ADDENDUM

Addendum #01

RE: Renovate 4E NMAL Office Suite

Smithsonian Facilities Project No. 2466904 Ayers/Saint/Gross Project No. 3000738

8/26/2025 10:34:40 AM A-406EP BY LKG 04/18/25 FINAL CONSTRUCTION DOCS

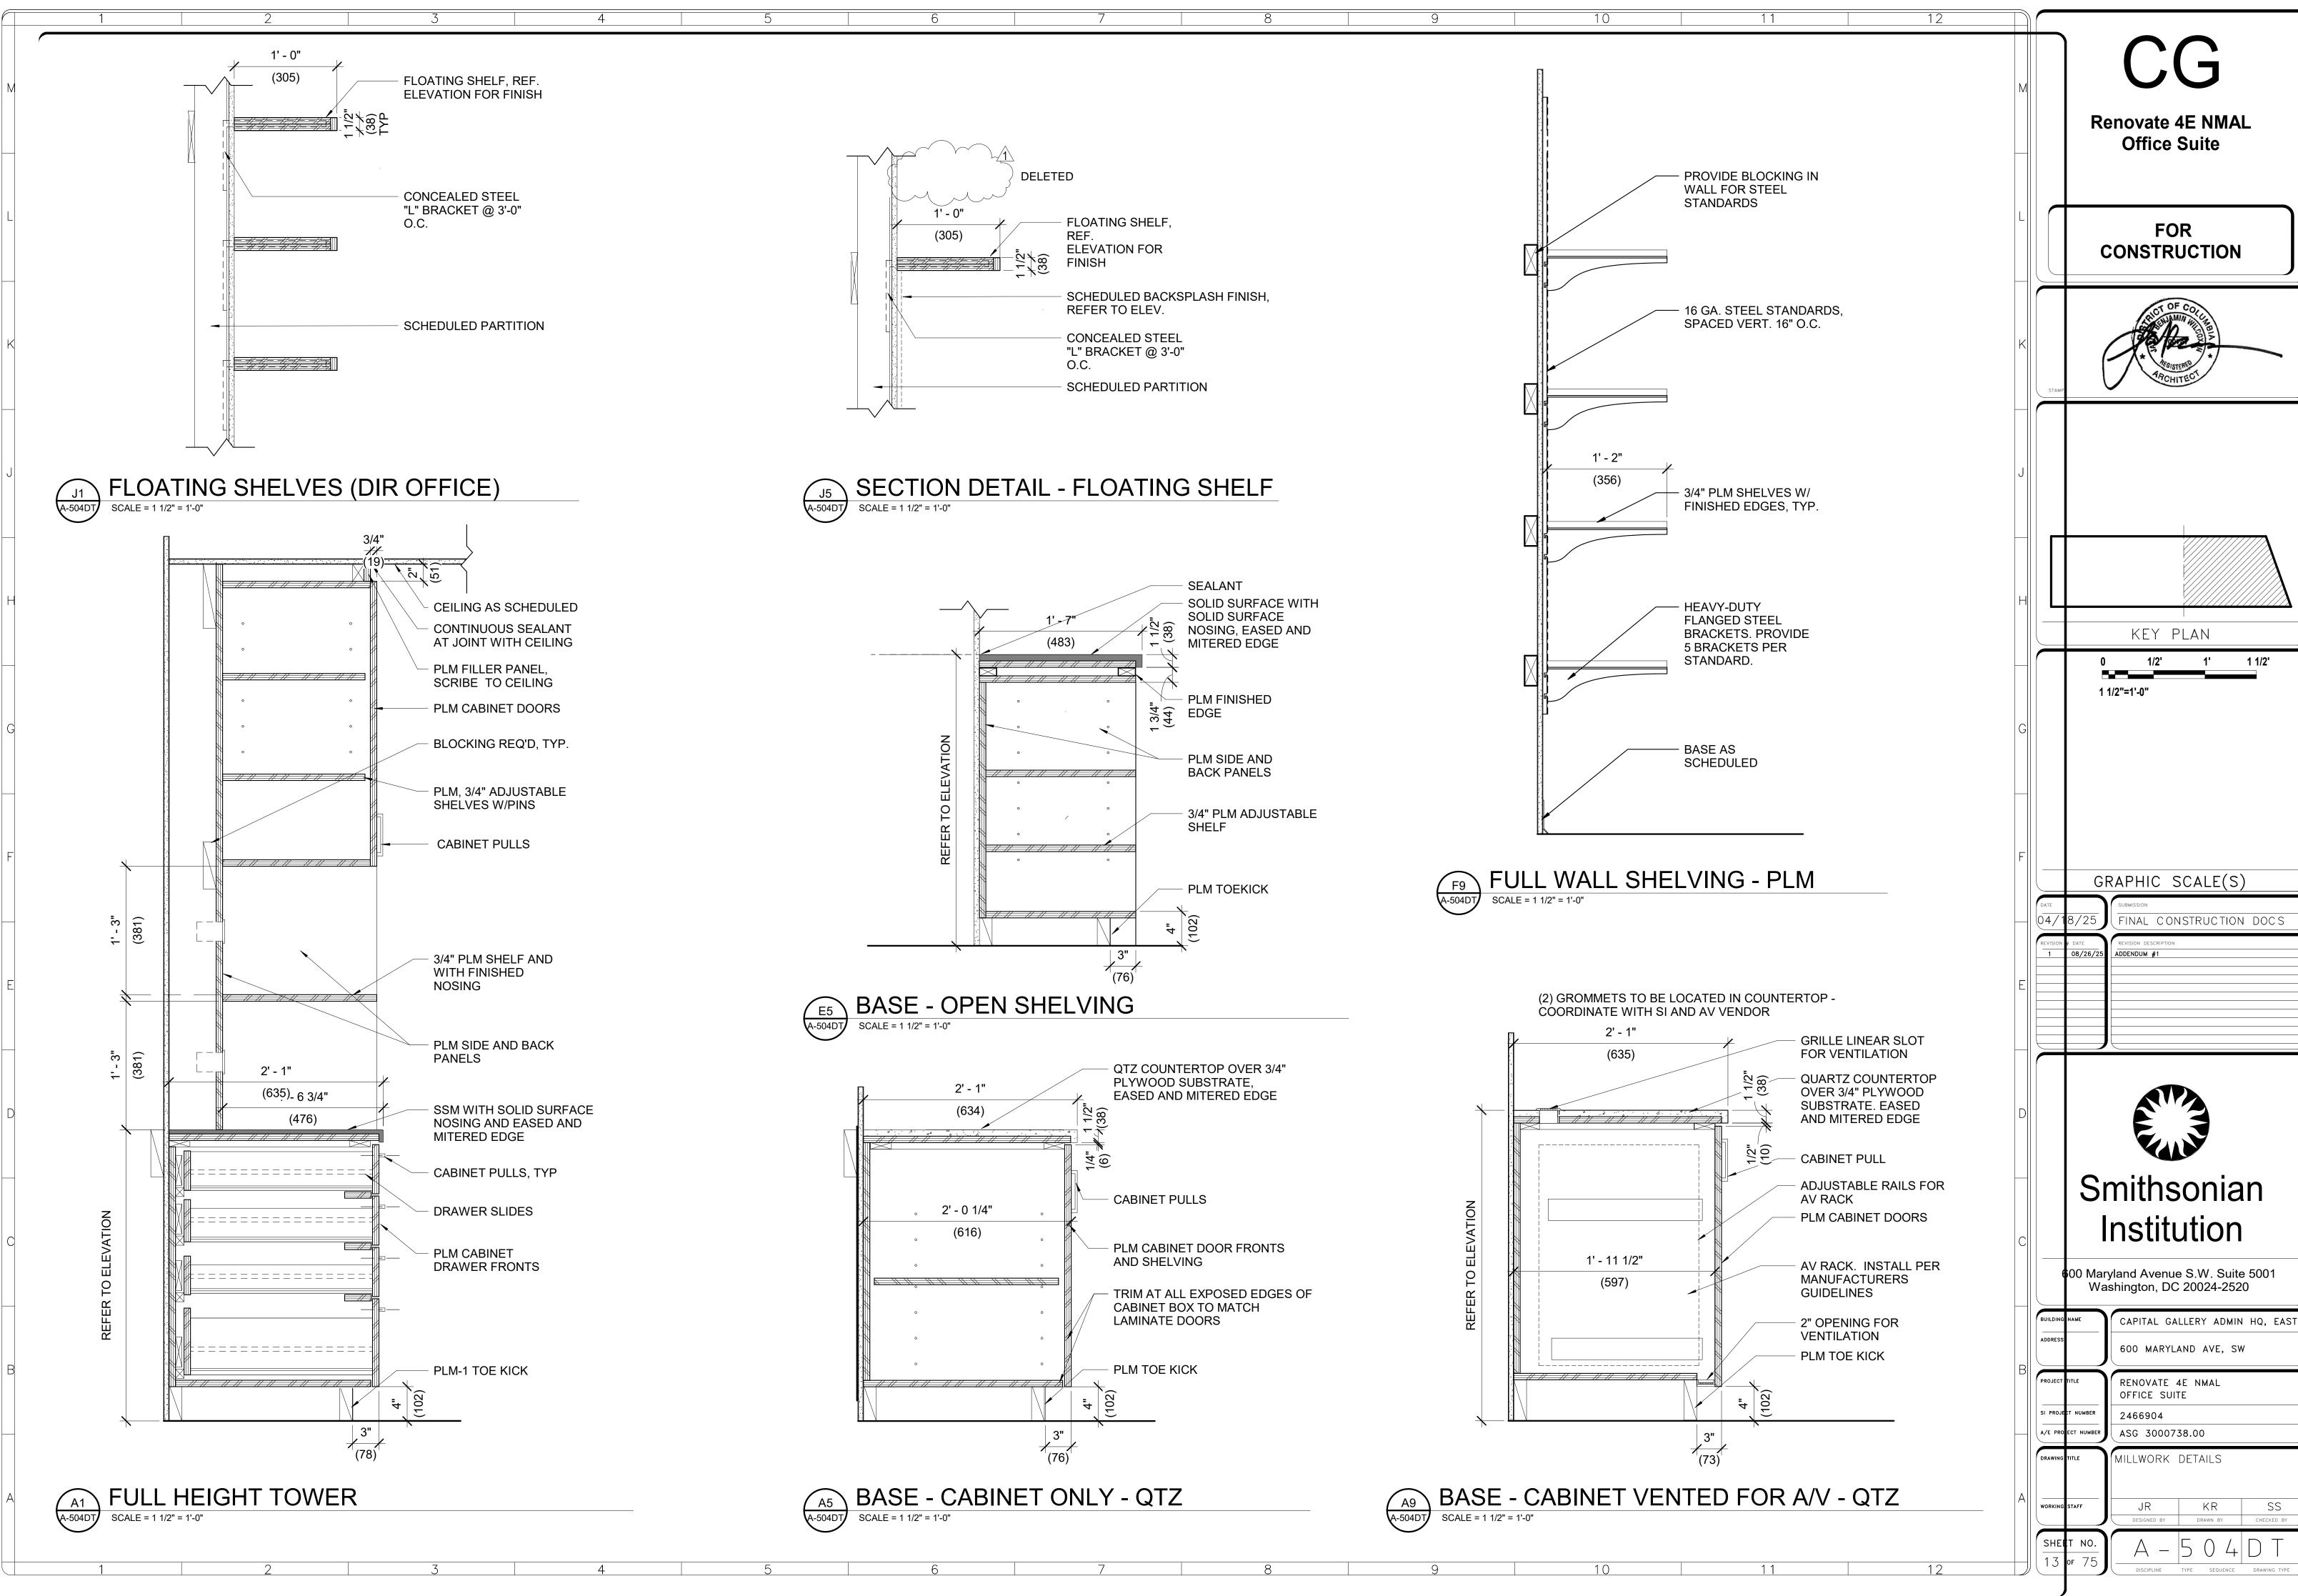
- Removed elevation of shelf in Director Office
- A-504DT MILLWORK DETAILS
 - Removed dimension at J5 section detail.
- A-902SH FINISH AND EQUIPMENT SCHEDULE & DETAILS
 - Added remark to PNT-1
- A-903SH DOOR SCHEDULE & DETAILS
 - Added door and frame finishes

ELECTRICAL SCHEDULES

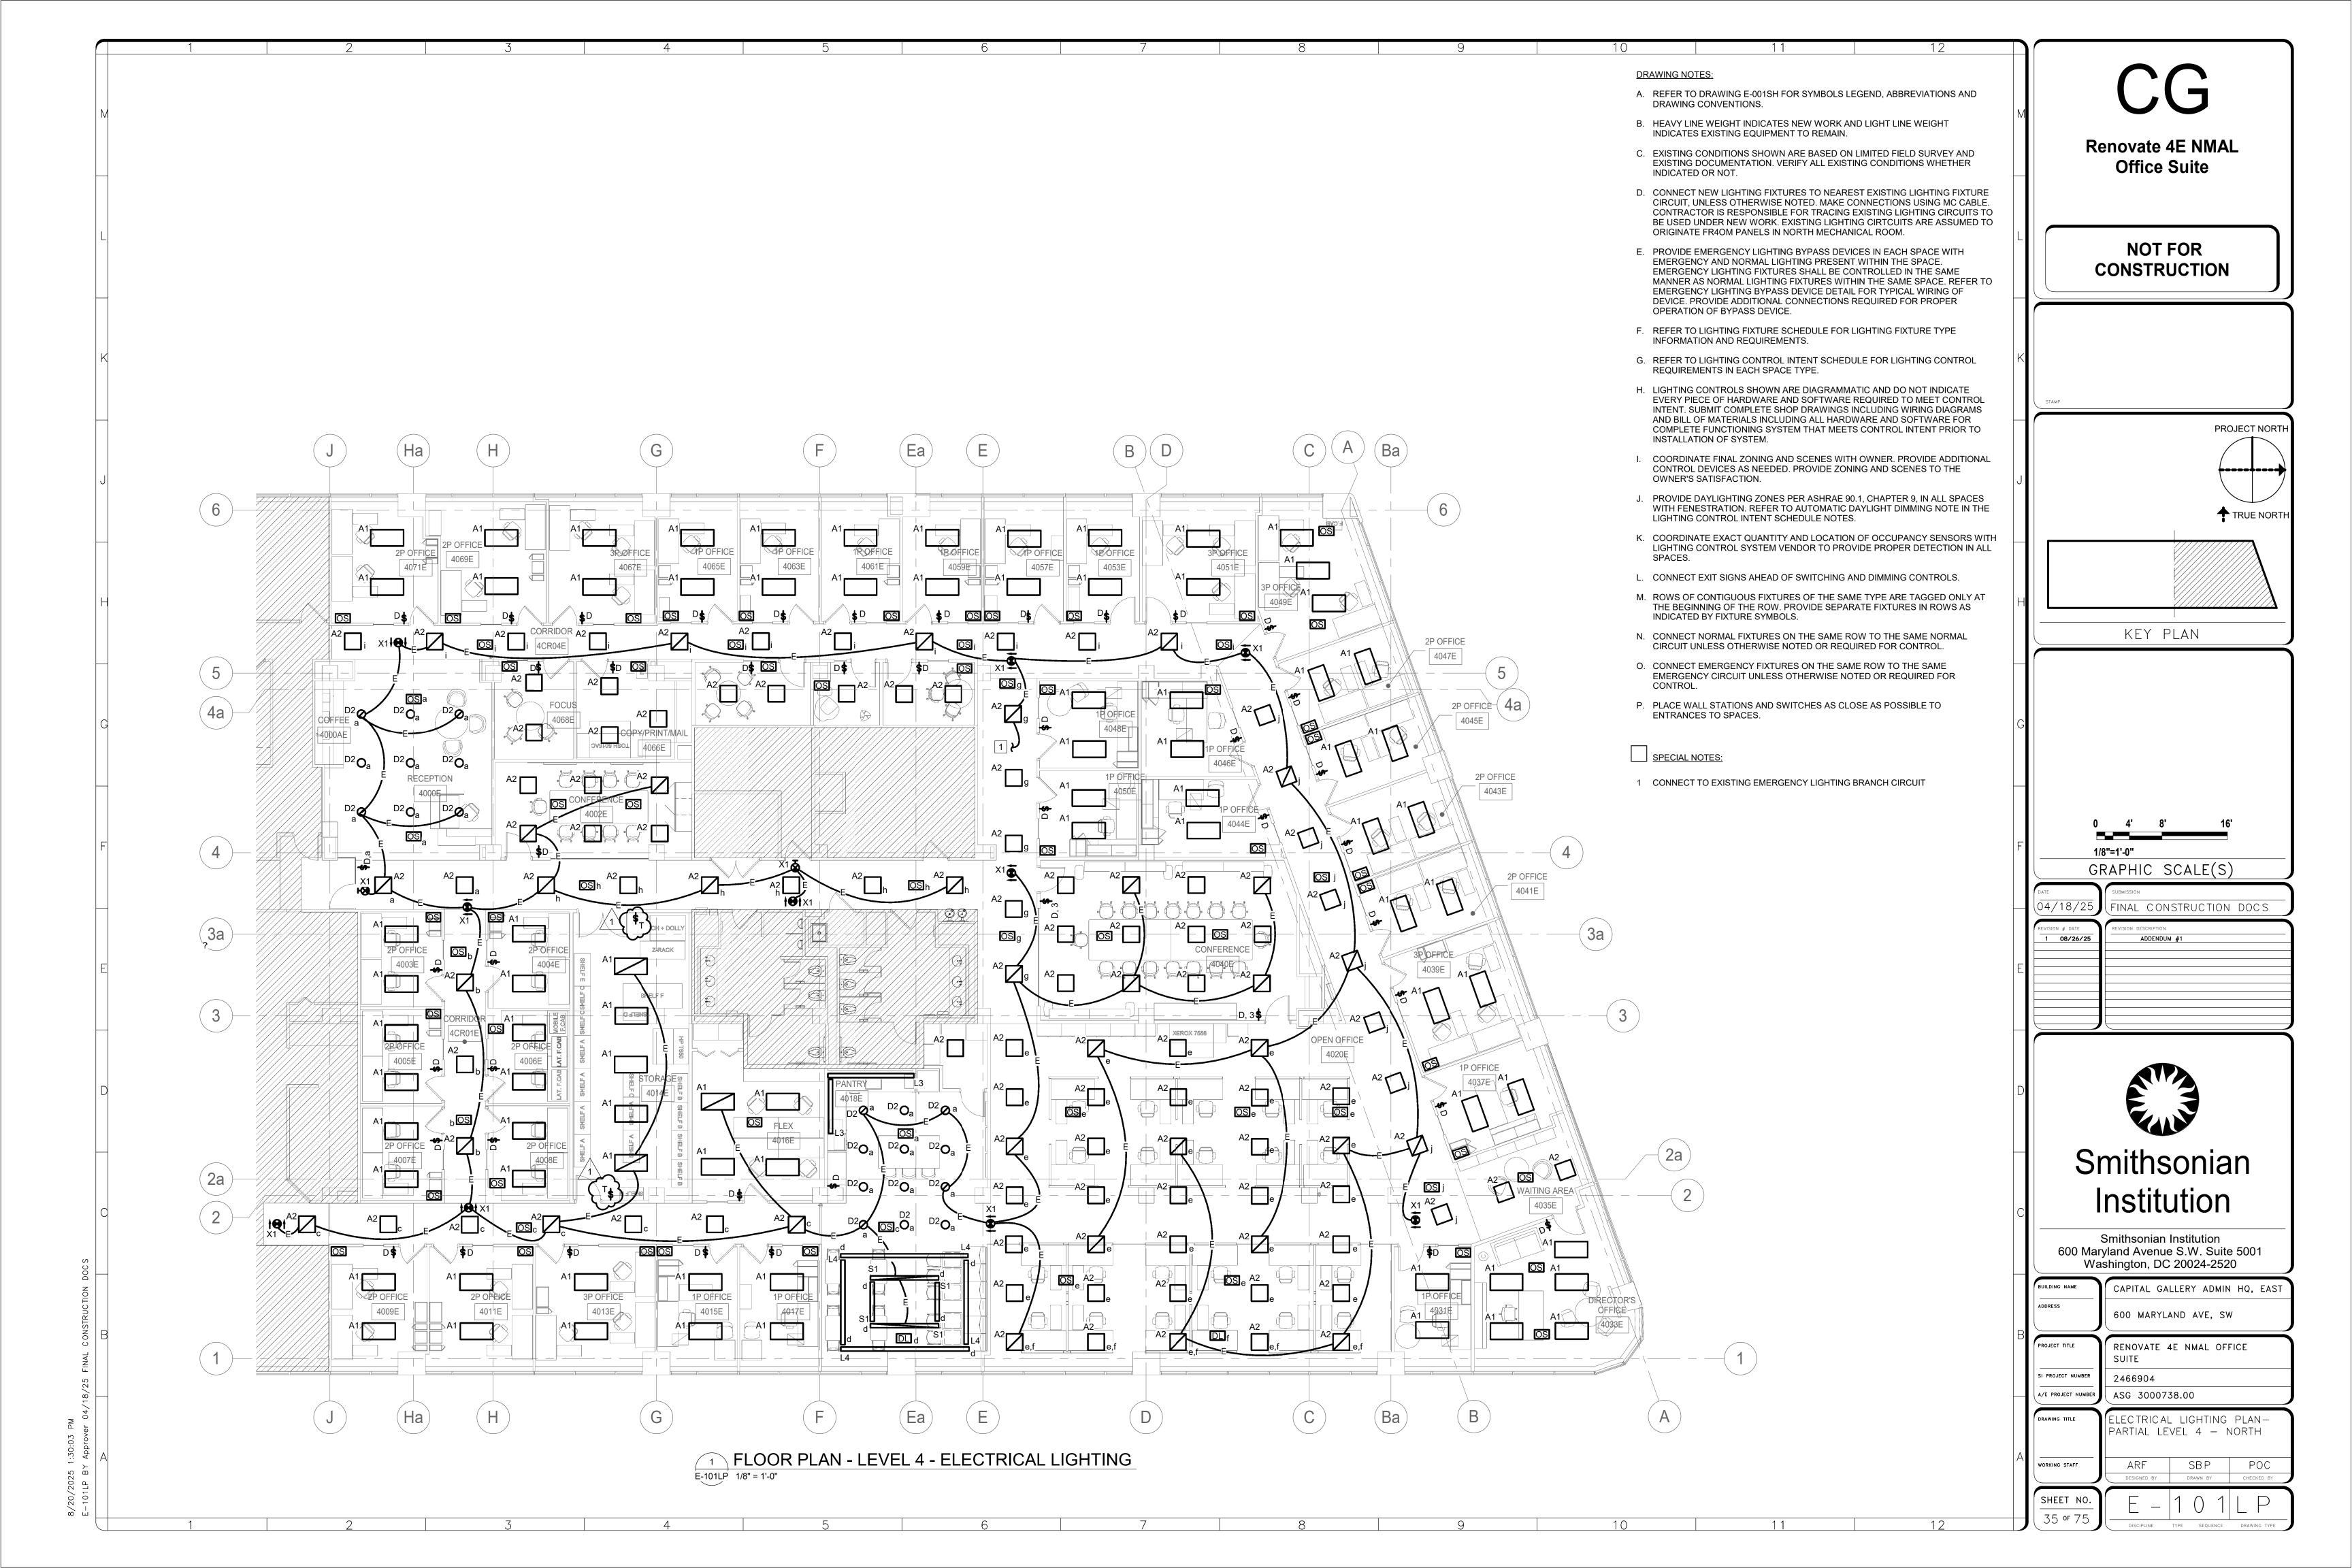
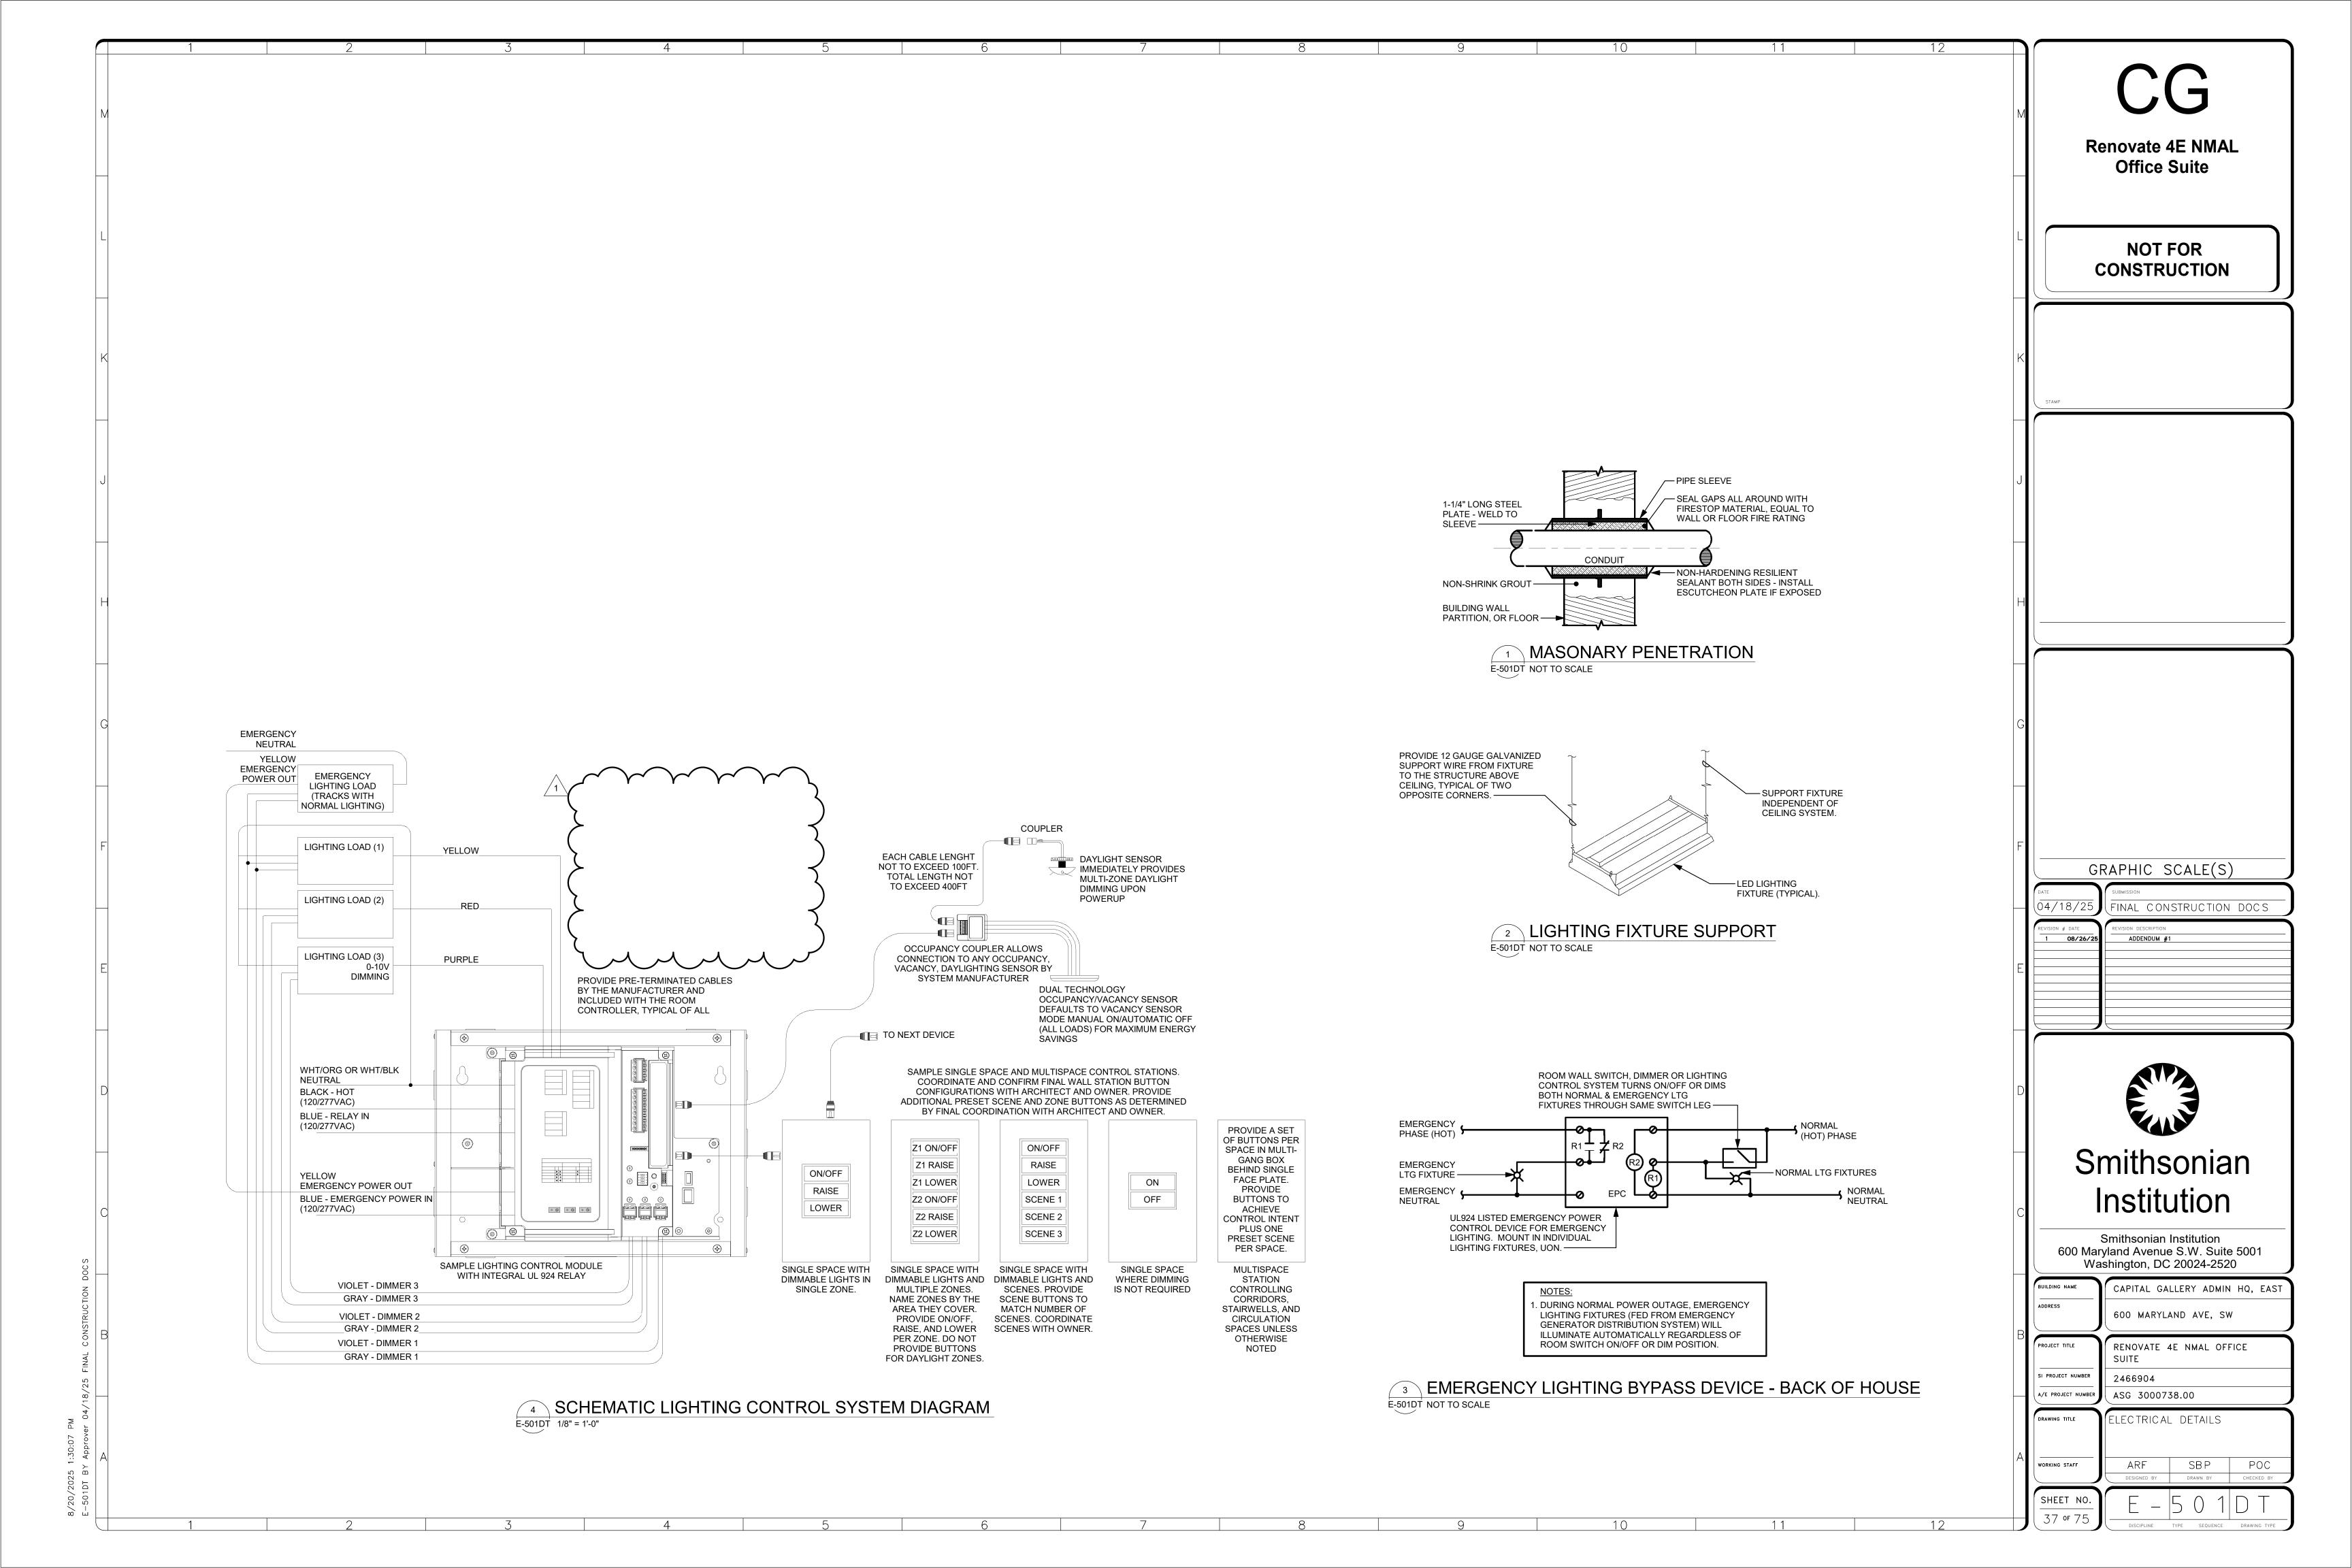
- E-101LP LIGHTING PLAN PARTIAL LEVEL 4 NORTH NEW WORK
 - Updated lighting controls in Storage 4014E to be timer switches
- E-501DT ELECTRICAL DETAILS
 - Removed controlled receptacle from Detail 4.
- E-601SH ELECTRICAL SCHEDULES
 - Added Lighting Control Intent Schedule and associate notes.
- E-602SH PANELBOARD SCHEDULES
 - Removed note about new panels
- E-603SH PANELBOARD SCHEDULES
 - Removed note about new panels
- E-902SS ELECTIRCAL SPECIFICATIONS
 - Removed specification language on bonding jumpers.
